Bulletin No.: 14295  
Date: July 2014

# Recall Bulletin

**SUBJECT:** Wiper Motor Stripped Gear

**MODELS:** 2013-2014 Chevrolet Caprice PPV  
2014 Chevrolet SS

**Label and Date Code as Viewed on Chevrolet SS**

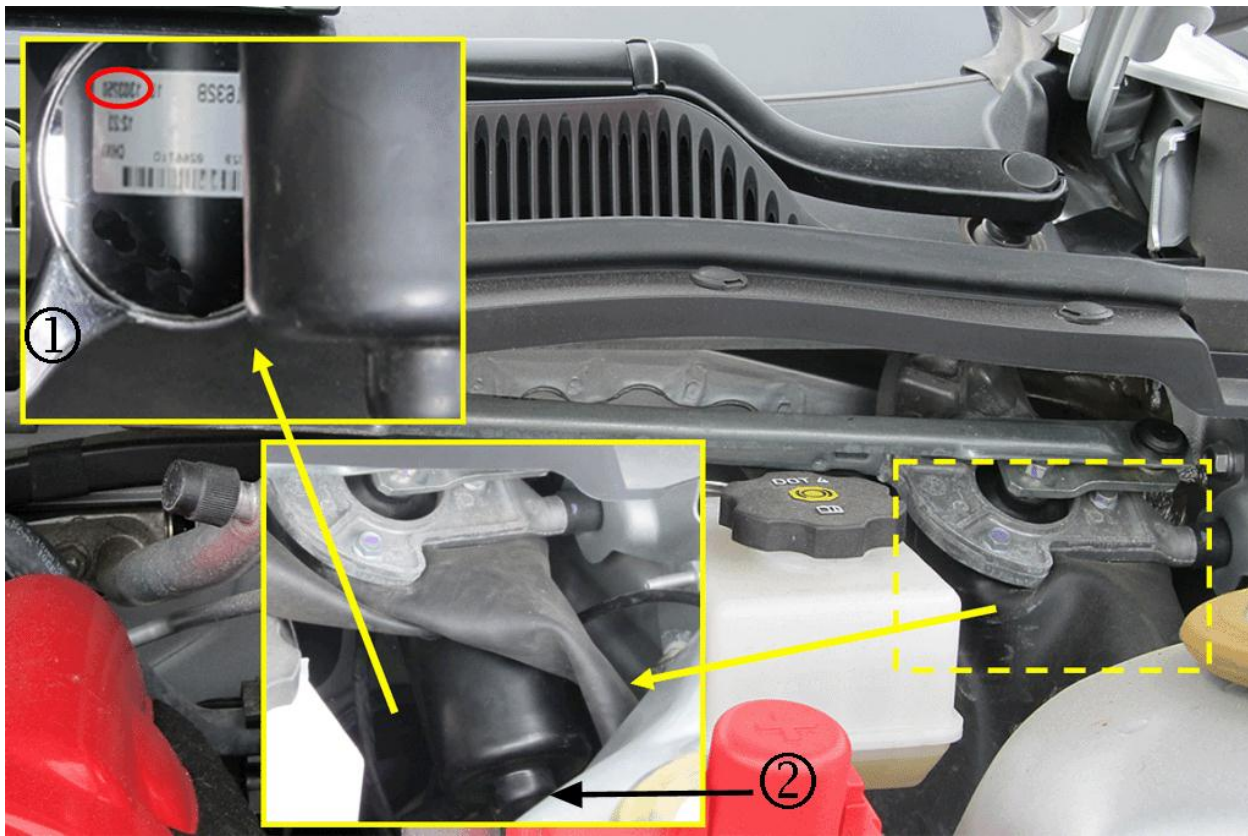
**NOTE:** Examples of the wiper motor water shield locations for Caprice PPV (1) and Chevrolet SS (2) are shown in the graphic above.

1. Open the hood and locate the windshield wiper motor water shield (shown circled).

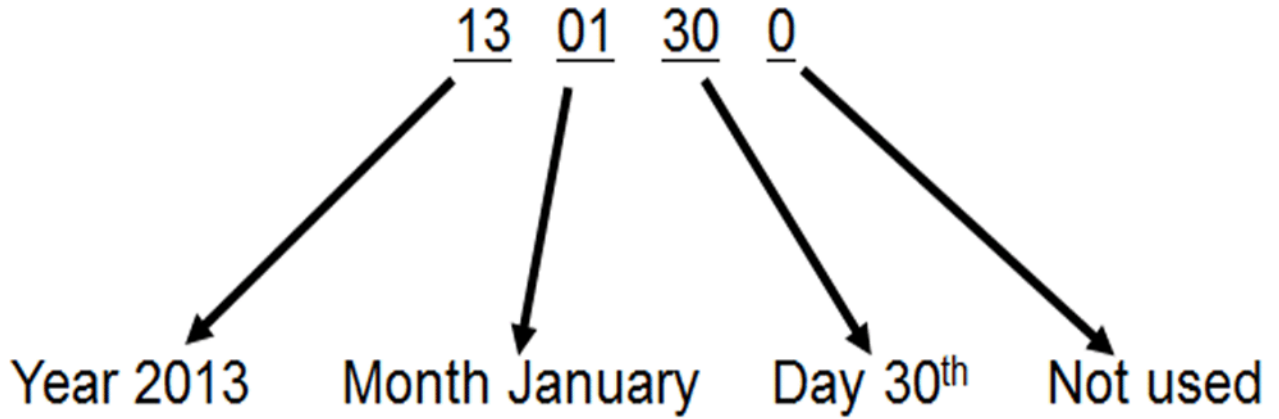
2. Reposition the water shield. Use a flashlight and inspection mirror (1) to view the

underside of the wiper motor (2). Inspect the date code on the wiper motor label.

**NOTE:** The number shown in the example above - 1301300 = January 30, 2013. The numbers are shown back to front in the mirror.

**The affected date range is between JANUARY 15, 2013 and AUGUST 05, 2013; so the corresponding date codes will be anywhere within the 130115 to 130805 number range.**

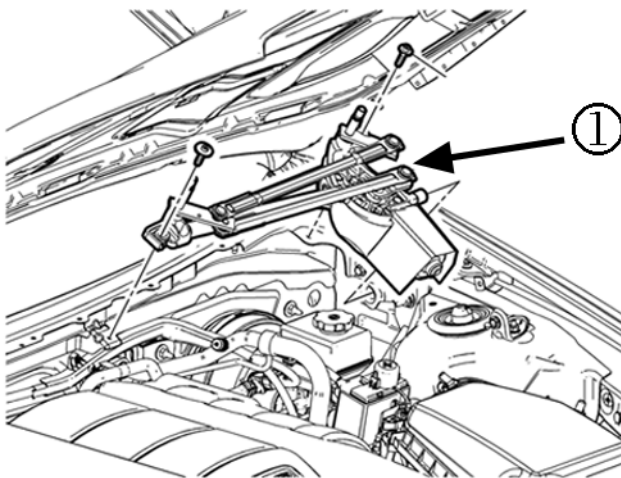
**NOTE:** There are two different labels that may be affixed to the wiper motors. To identify how to read the date codes, follow the examples shown below.

**Example (1):** The date is the first six digits in the top corner of the label. The date on the motor in this example is 130608, which is June 08, 2013 (AFFECTED).

**Example (2):** The date is part of the barcode number and starts from the sixth digit. The date on the motor in this example is 110108, which is January 08, 2011 (NOT AFFECTED).

- If the date is within the timeframe from **JANUARY 15, 2013 to AUGUST 05, 2013**, the wiper motor DOES contain the failure issue and you should move directly to the *Service Procedure* below.
- If the date DOES NOT fall within the dates shown above, no further action is required. Reposition the wiper motor water shield and close the hood.
